Access Compliance Report

Public Rights-of-Way

Intersection ID: N/A	Main Street: INVERNESS_BAY_RD	Cross Street: PERTH_MOOR_RD	Location: NW
ADA ID: C2F96BF1DAAC	Ramp Type: Perp	Initial Pass/Fail: Fail	Overall Compliance: No
		Severity Score: 10

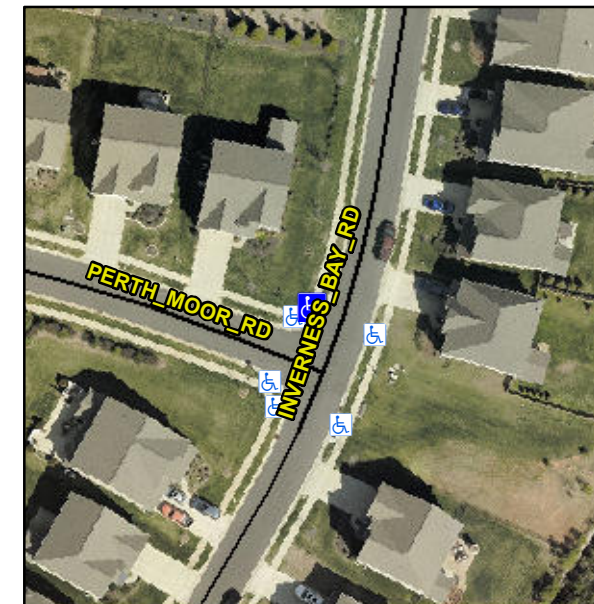
R304.5.1, R304.5.3

Compliance	Description	Data	Compliance	Description	Data
N/A	Ramp Length (in)	47.5	Yes	Ramp Slope (%)	7.1
No	Ramp Width (in)	42.0	No	Ramp XSlope (%)	4.3
N/A	Flare Type LT	N/A	N/A	Flare Type RT	N/A
N/A	Flare Slope LT (%)	N/A	N/A	Flare Slope RT (%)	N/A
N/A	Flare Traversable LT?	N/A	N/A	Flare Traversable RT?	N/A
N/A	Landing Length (in)	N/A	N/A	DWS Provided?	N/A
N/A	Landing Width (in)	N/A	N/A	DWS Contrast?	N/A
N/A	Landing Slope (%)	N/A	N/A	DWS Length (in)	N/A
N/A	Landing X Slope (%)	N/A	N/A	DWS Full Width?	N/A
N/A	Landing Curb? (Y/N)	N/A	N/A	DWS Offset (in)	N/A
N/A	Shared Landing?	N/A			
N/A	Gutter Ponding?	N/A	N/A	Gutter Slope (%)	N/A
N/A	Gutter Lip Ht (in)	N/A	N/A	Gutter X Slope (%)	N/A
N/A	Painted X Walk1?	No	N/A	Painted X Walk2?	N/A
	X Walk 1 Direction	To SE		X Walk 2 Direction	N/A
N/A	X Walk 1 Width (in)	N/A	N/A	X Walk 2 Width (in)	N/A
	X Walk 1 Slope (%)	0.8		X Walk 2 Slope (%)	N/A
	X Walk 1 X Slope (%)	3.4		X Walk 2 X Slope (%)	N/A

Remove & Replace Entire Ramp.
